Error ratio requirements in receiver tests

(In support of comments #52, #85, #94, #105,
and #106 against D3.0)

Adee Ran, Cisco

Table 176C-5 (corrected values)

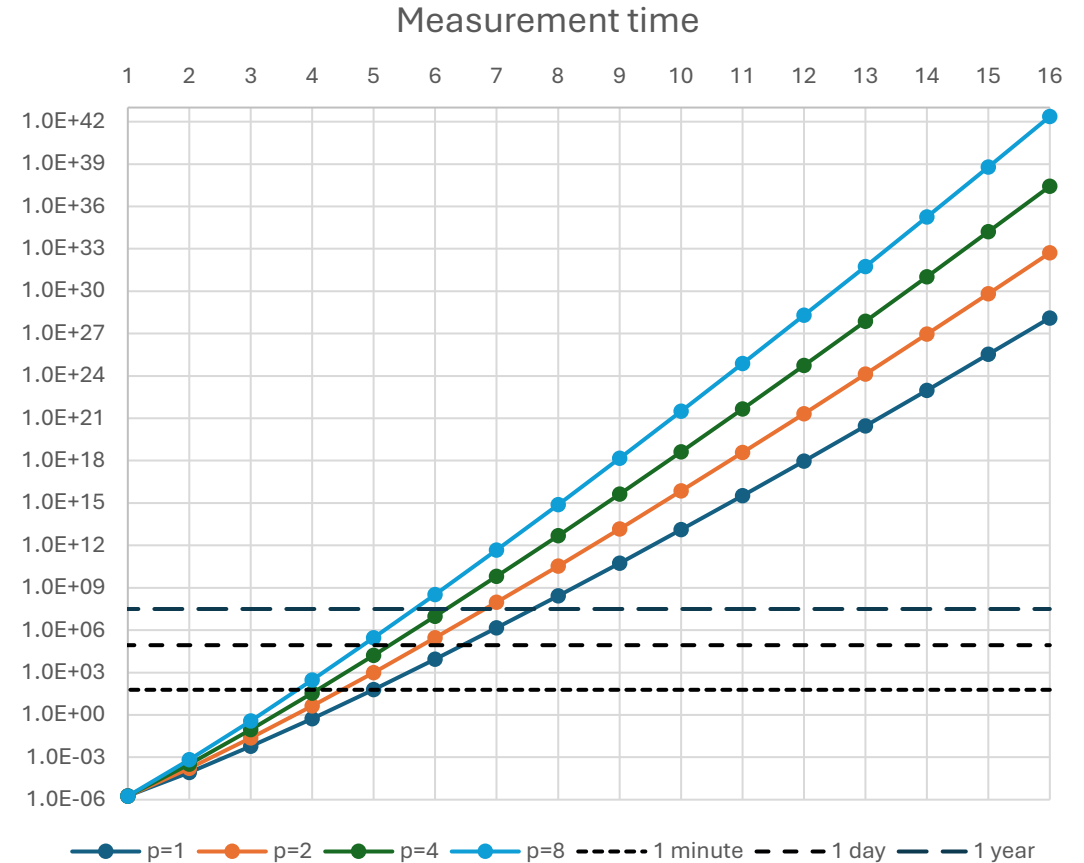
- Per 174A.9.5: “The expected BLER is met if, for each lane i , $H_m^{(i)}(k)$ is less than $H_{\max}(k)$ for all $k > 0$ ”.
- measurement should be long enough to verify that the event probability is lower than the required value.
 - Typically, measurement time is defined as least 3 times the mean time between events (if no events are observed).
 - The number 3 is associated with a confidence level of 95% and is insignificant in this case.
- I calculated the required times for each value in each table.
 - Verifying the largest values of k is not feasible/practical (especially with AUIs or with $k > 1$), making the requirement impossible to verify without some extrapolation.
 - A similar issue exist in optical PMD clauses and is addressed by informative notes. The electrical PMDs and AUIs do not have such notes.

- Add the following NOTE after Table 176C-6, **based on 180.9.16:**
NOTE—If the statistical projection is modeled accurately by a linear fit extrapolation, a means to provide statistical projection of the measured histograms (see 174A.9.3) in order to reduce test time follows. Extrapolate the measured histogram to $H_m^{(i)}(16)$ using a line determined by a linear fit of $\log_{10}(H_m^{(i)}(16))$, for $k = 1$ to n , where n is the largest value of k for which all bins from 0 to k have a count greater than 2.
- Add similar notes after Table 176D-10, Table 178-11, and Table 179-13.
